X 91.003-26

MODEL PS 50

SUSPENSION/HARNESS

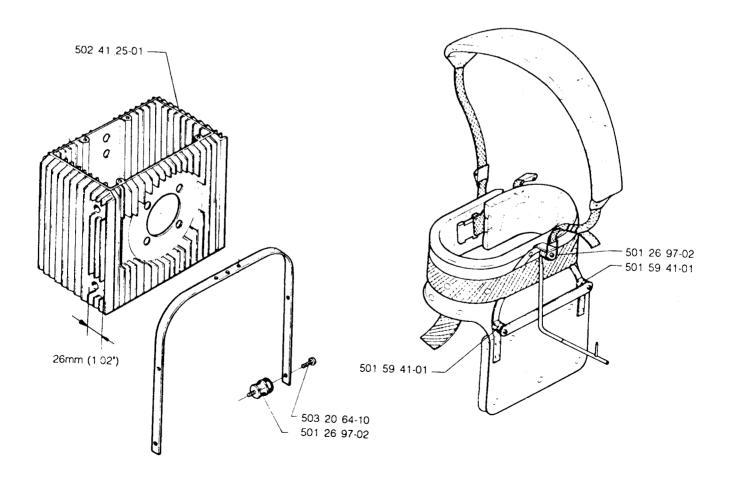
In order to receive a more stable suspension of the engine unit, a stronger AV-element is introduced between the suspension frame and the hydraulic tank. Also the upper AV-element to the harness is replaced. At the same time, the diameters of the recesses in the hydraulic tank are increased from 22 mm (0.87) to 26 mm (1.02).

The hydraulic tank Ref. no. 502 41 25-01 remains unchanged.

The change is introduced from serial number: 1010001.
